# Product Change Notification

<b>Date Issued :</b>	May 12, 2023	<b>PCN Number :</b>	513402
<b>Reason for Change :</b>	Change to Product		
<b>Description of Change :</b>	The recommended PCB layout in the drawing for PN 855437002 has been changed; there is no form/fit/functional impact on the part.		
<b>Reason for Short Notice :</b>	Special Request		
<b>Assessment of Change :</b>	No change to parts - Form/Fit/Function		
<b>Planned Implementation Date :</b>	July 15, 2023		
<b>Sample Availability Date:</b>	May 31, 2023		
<b>Internal Molex Qualification Date :</b>	May 31, 2023		
<b>Last date to request Samples by Customer :</b>	June 30, 2023		
<b>Traceability Code Markings / Date :</b>	No special marking on the product or packaging

Before Picture

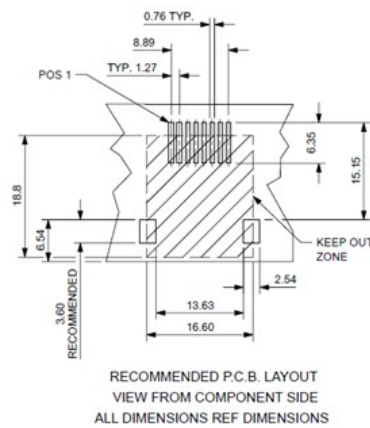
- The recommended PCB layout in the drawing for PN 855437002 has been changed; there is no form/fit/functional impact on the part.
